Beach Lodge  
1 Strand Way  
Felpham

Alterations and Extension to Existing

Proposed Elevations

Drawing No.  
PL104.C

**Proposed Non-Material Amendment 3**

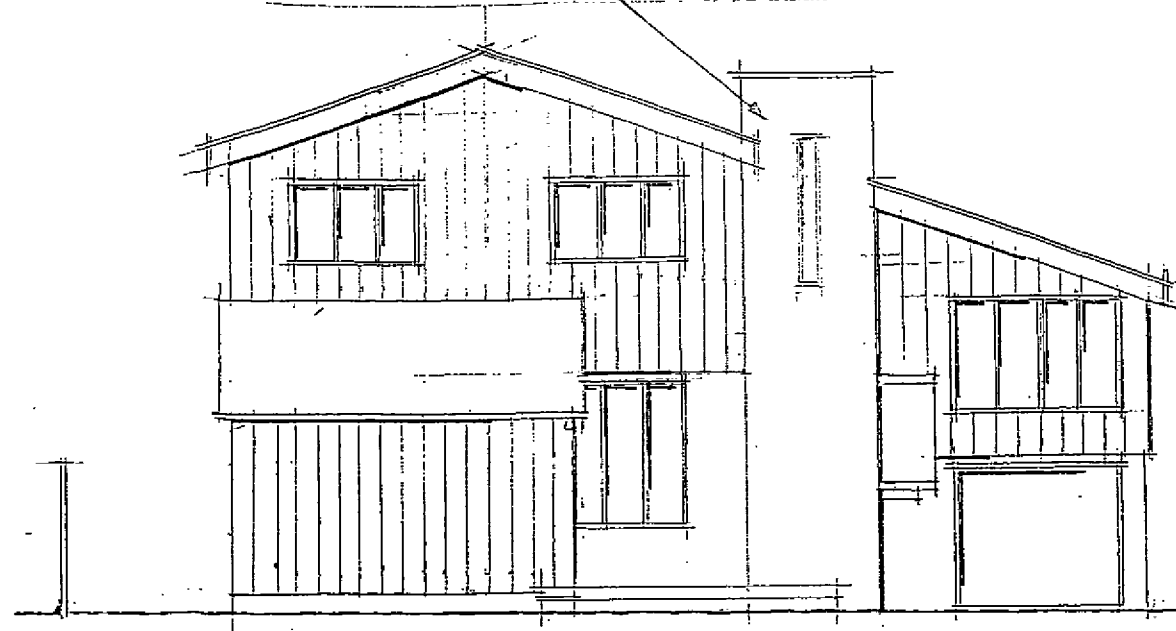
Introduce a slot window into the former lift shaft to allow light into the storage room and to improve the visual appearance

**Proposed Non-Material Amendment 1**

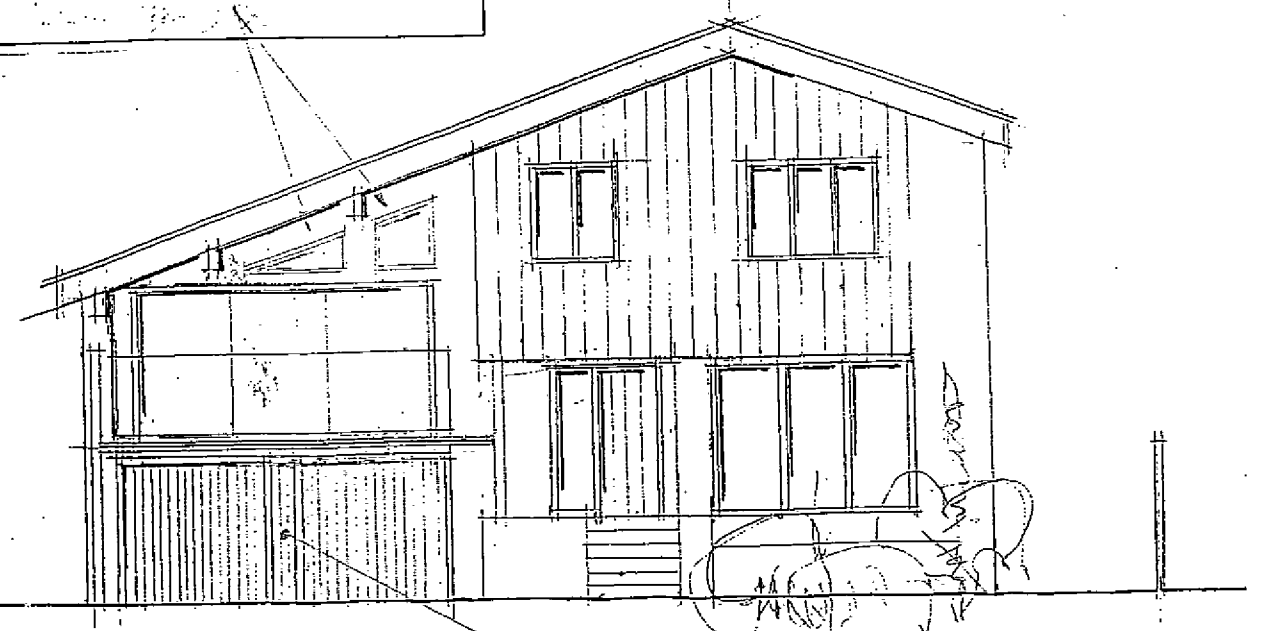
Re-introduce a proportion of the original glazing arrangement (Ref. Drawing PL102 Elevations as Existing) to allow direct light into the upper part of the vaulted ceiling in the Drawing Room
